PREVOST

WARRANTY BULLETIN

Wb04-04

DATE : APRIL 2004	SECTION : 01 - Engine
EXPIRATION: APRIL 2006	
SUBJECT : REPLACEMENT OF HOSES AND CLAMPS AND VERIFICATION OF MINIMUM CLEARANCE ON THE CHARGE AIR COOLER (CAC) SYSTEM

FIGURE 1: HOSE AND CLAMPS REPLACEMENT (ref. step 1A)

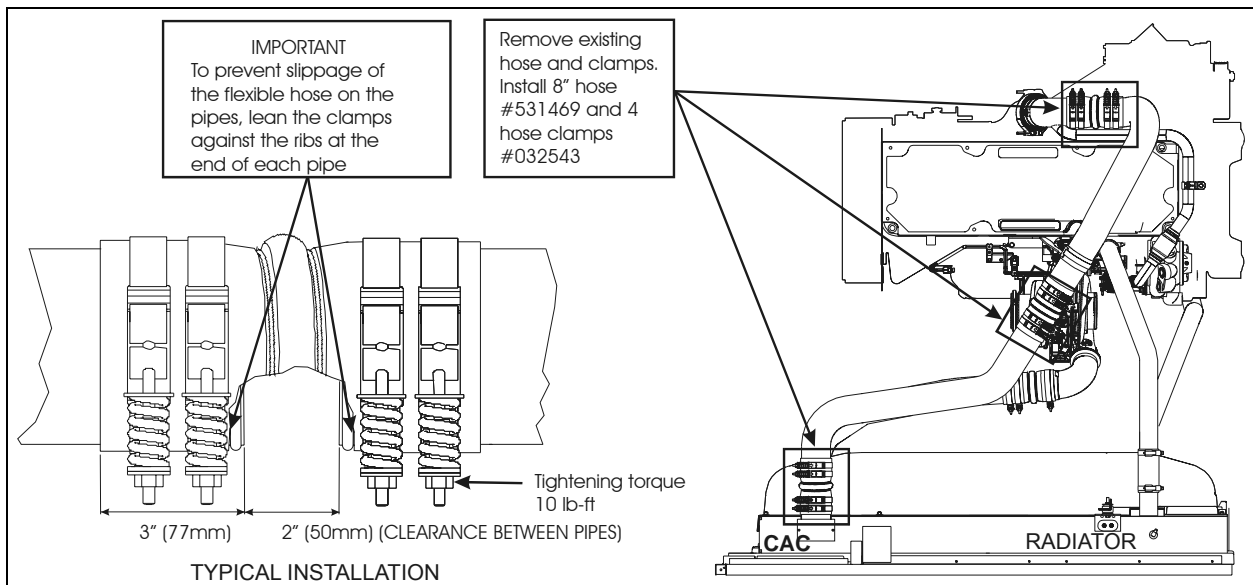
1A. On the pipe going from the charge air cooler (**CAC**) outlet to the engine air intake, remove the existing hose and clamps. Install 8" hose (#531469) (*figure 1*) and 4 hose clamps (#032543) on each connection. Tighten the clamps to a torque of 10 lb-ft.

FIGURE 2: HOSE AND CLAMPS REPLACEMENT (ref. step 2A)

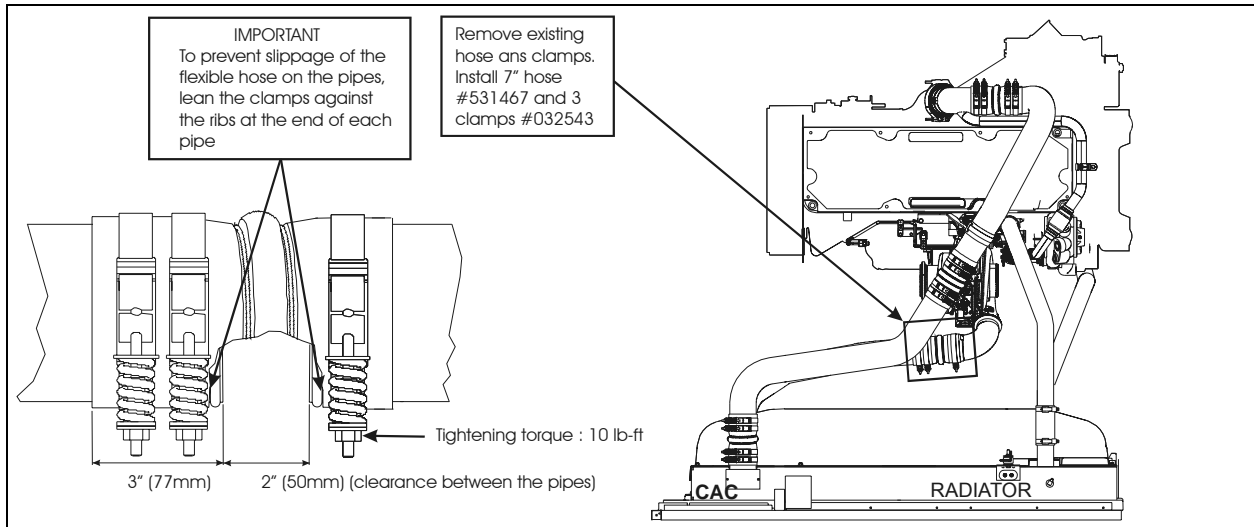
2A. At the turbocharger outlet, replace the existing hose and clamps. Install 7" hose (#531467) and 3 hose clamps (#032543). Tighten the clamps to a torque of 10 lb-ft (figure 2).

FIGURE 3: HOSE AND CLAMPS REPLACEMENT (ref. step 3A)

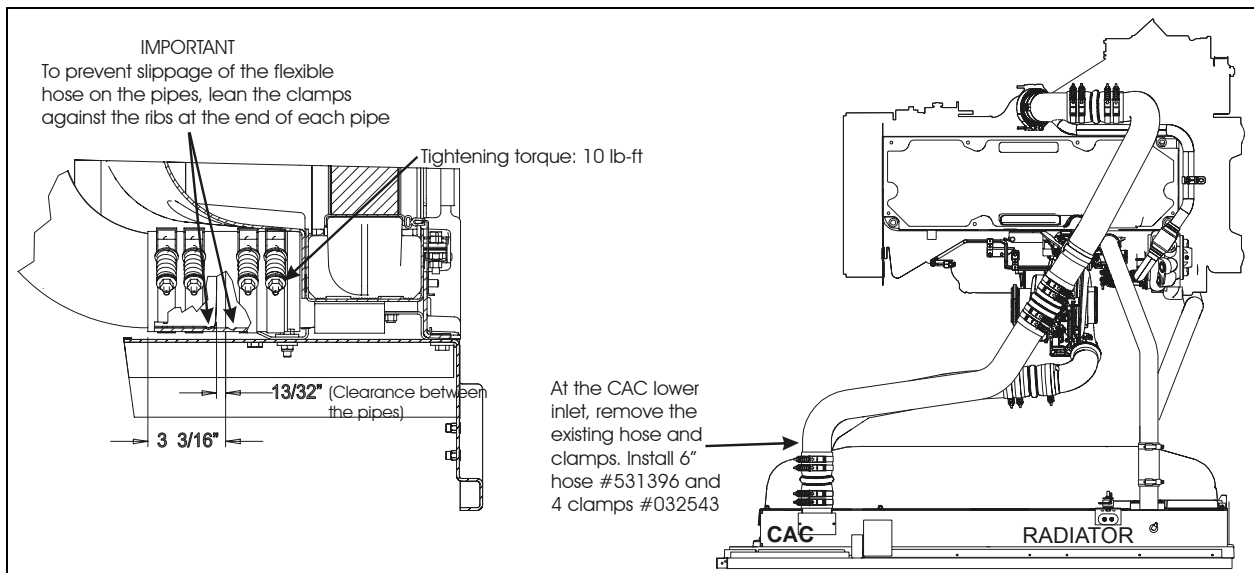
3A. At the CAC lower inlet, remove the existing hose and clamps. Install 6" hose (#531396) and 4 hose clamps (#032543) as per figure 3. Tighten the clamps to a torque of 10 lb-ft. **Important**, the 6" hose (#531396) may already have been installed at the factory. Check if the hose in place measures 6" long. If it does, just add clamps to have 4 of them.

Important: Leave a gap of 13/32" between the pipe and the inlet tip (figure 3). In order to have the CAC inlet tip perfectly align with the pipe coming from the turbocharger outlet, untighten the clamps and rotate the turbocharger outlet as needed (figure 5).

FIGURE 4: SPACER #032540 (ref. step 1A)

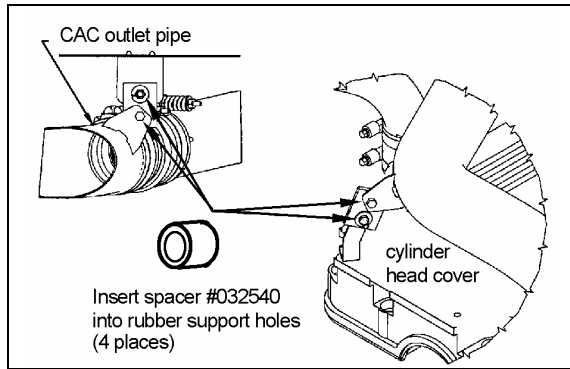
Note: Unless it has already been done at the factory, insert 4 spacers (#032540) into the rubber support holes (*see figure 4*).

FIGURE 11: TRANSMISSION DIPSTICK TUBE SUPPORT (ref. step 5A)

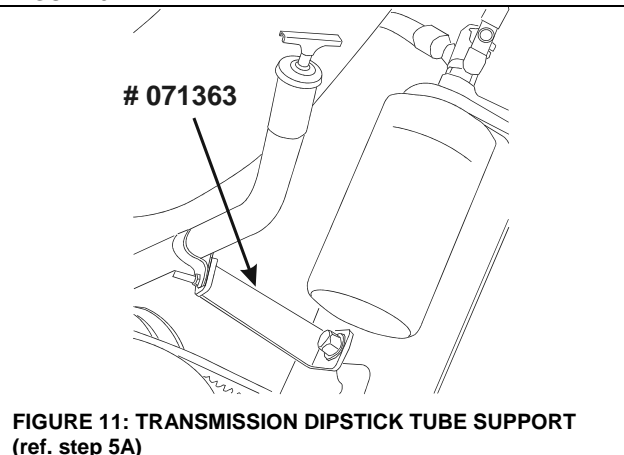
5A. If the minimum clearance around the transmission oil dipstick tube cannot be met, replace the support by the new support (#071363) (figure 11). **Important**, support #071363 may have already been installed on your vehicle at the factory. Compare your support with the one of figure 11.

- 4B. If the minimum clearance around the transmission oil dipstick tube cannot be met, replace the support by the new support (#071363) (*figure 11*). **Important**, support (#071363) may have already been installed on your vehicle at the factory. Compare your support with the one of *figure 11* in part A.

FIGURE 12: HOSE AND CLAMPS REPLACEMENT (ref. step 1B)

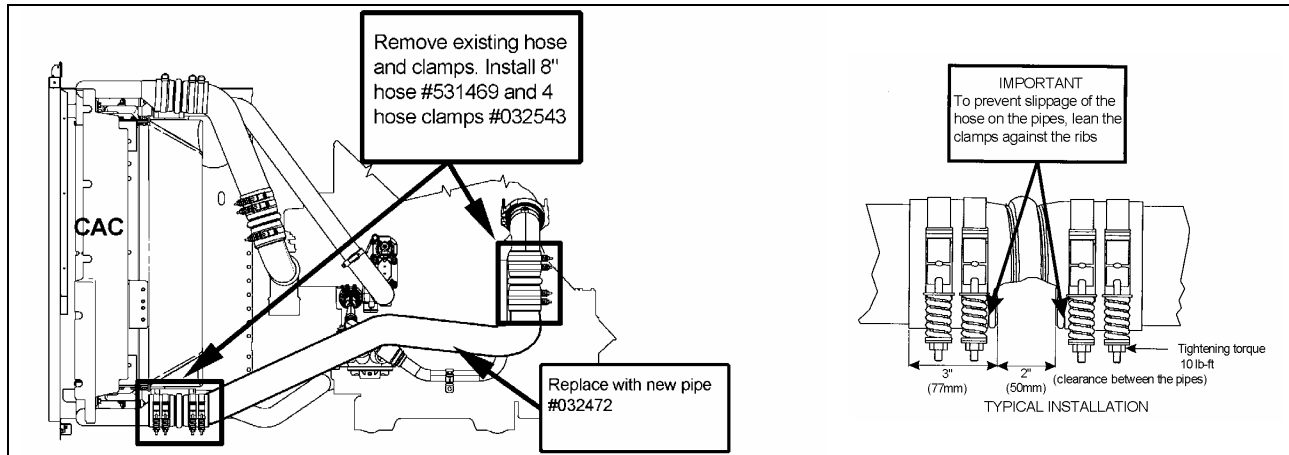
1B. Replace the pipe between the CAC outlet and the engine air inlet by the modified pipe (#032472). Reinstall using 8" hose (#531469) (figure 12) and 4 hose clamps (#032543) on each connection. Tighten the clamps to a torque of 10 lb-ft. If this pipe is not replaced, it will not be possible to install the required quantity of clamps.

FIGURE 13: HOSE AND CLAMPS REPLACEMENT (ref. step 2B)

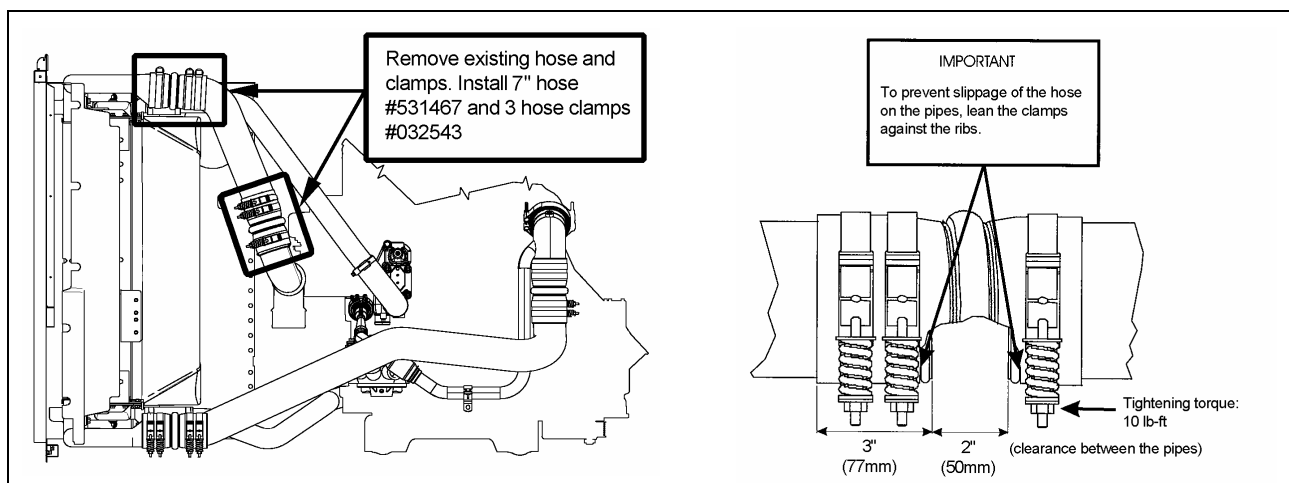
2B. On the pipe between the turbocharger outlet and the CAC inlet, remove the hose and clamps. Install 7" hose (#531467) and 3 clamps (#032543) as per figure 13. Tighten the clamps to a torque of 10 lb-ft.

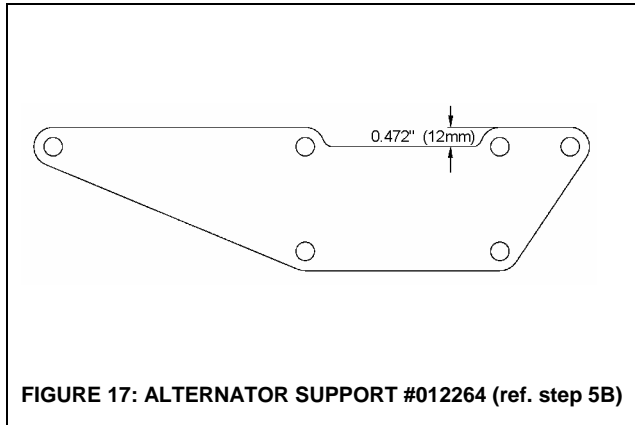
- 6B. If the minimum clearance around the turbocharger inlet pipe cannot be met, replace the pipe by the modified pipe (#032538). Transfer the relative humidity sensor, the air filter obstruction indicator and the air compressor inlet hose on the new pipe (*see figure 18*). Once completed, check for the minimum clearance and correct if needed.
